TECHNICAL BULLETIN

MODEL/DERIVATIVE:
Discovery Series II
Defender

Bulletin N°: 0026
CDS. ref: L8616bu
Issue: 1
Date: 23.08.2000

ENGINE MISFIRE - ENGINE HARNESS OIL CONTAMINATION

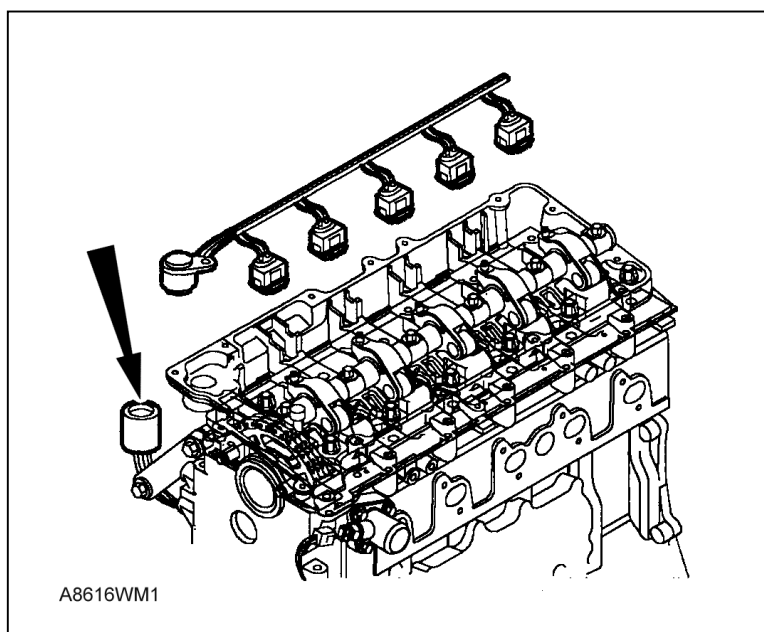
Poor sealing in the injector harness connector, allowing engine oil to migrate through the connector and into the engine harness, resulting in poor electrical contact. It is possible that oil may reach the engine management ECU connector.

Upon customer complaint of engine misfire, poor performance or failure to start, disconnect the engine harness at the cylinder head multiplug, (arrowed in illustration) and inspect for evidence of engine oil.

If engine oil is present within the connector, renew the respective harnesses as detailed below.

Land Rover Parts now supply harnesses having improved internal sealing. There are no changes to part numbers, refer to *PARTS INFORMATION* for specific applications.

1. Renew the fuel injector harness, Workshop Manual repair number **86.70.22** refers.
2. Renew the engine harness, Workshop Manual repair number **86.70.17** refers.
3. When renewing the engine harness, inspect the ECU connector for evidence of engine oil. If oil is present, clean the ECU connectors with electrical contact cleaner before connecting the new harness. ***IT IS NOT NECESSARY TO RENEW THE ECU.***
4. Use TestBook to remove any fault codes stored in the ECU and to extinguish warning lights.
